FIGURE 1A***Response to Arguments***

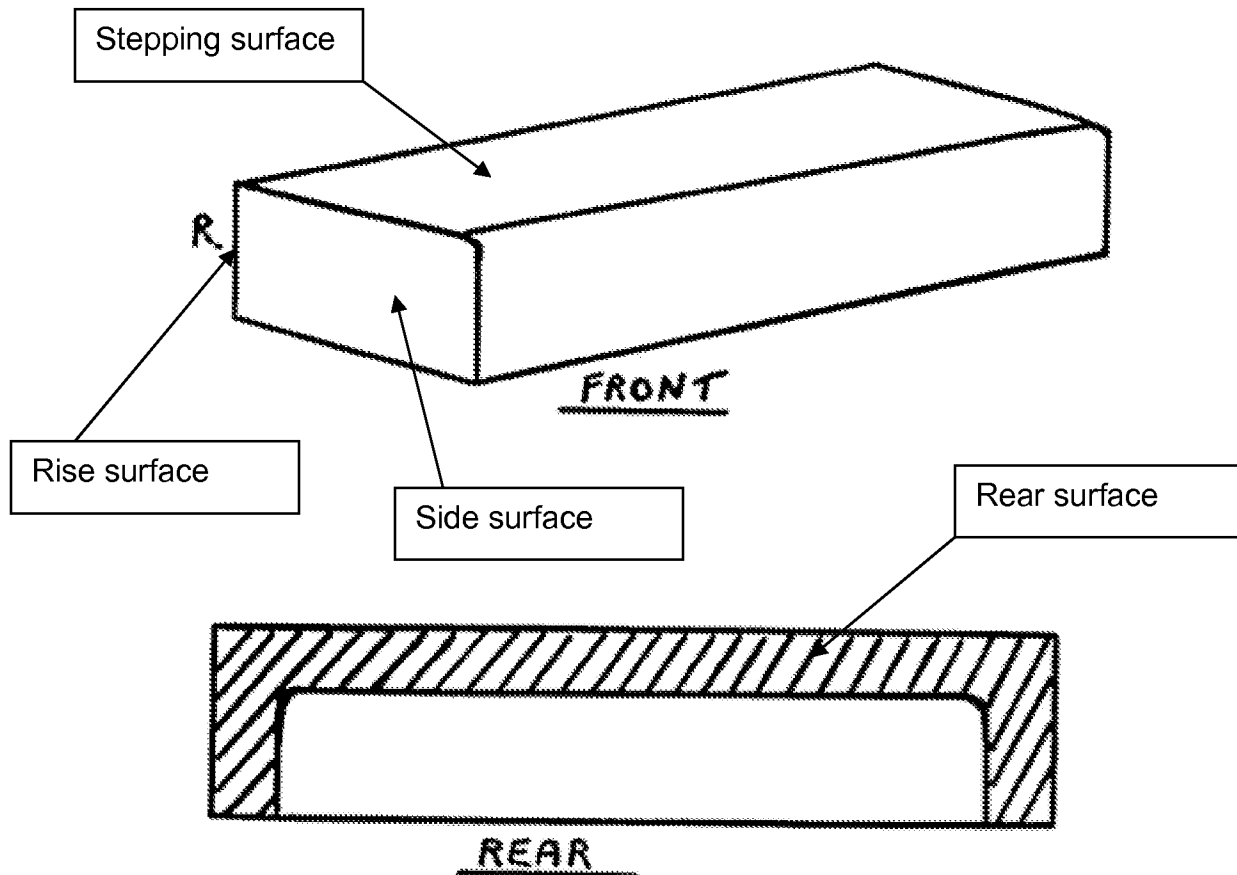
As per claim 1, Millar teaches a pre-cast concrete block for constructing a staircase (precast reinforced concrete step; abstract), comprising a horizontal stepping surface (as illustrated, the step has a horizontal stepping surface; figure 1A below), a

rise surface perpendicular to the stepping surface (as illustrated, the step has a rise surface which is perpendicular to the stepping surface; figure 1A below), and a rear surface (as illustrated, the step has a rear surface; figure 1A below); the rear surface having a recess for reducing the weight of the block (as illustrated, the rear surface is hollowed out; figure 1A below; this will reduce the weight of the step), the recess having round parts, with a specified radius at inner corner parts of the recess (as illustrated, the step has rounded surfaces at the inner corner parts; figure 1A below); wherein the round parts form a partially cylindrical recessed surface (a partial shape of a cylinder is curvilinear whose arc can range anywhere between 0 and 360 degrees; the rounded surfaces shown in figure 1A below can be described as partially cylindrical to a person having ordinary skill in the art; figure 1a below).

Millar fails to disclose the step is formed in a triangle pillar with a rear surface which connects diagonally the stepping surface and the rise surface at respective edges thereof.

In addition, Millar discloses side surfaces (figure 1A below), but fails to disclose displacement prevention grooves in respective side surfaces of the block.
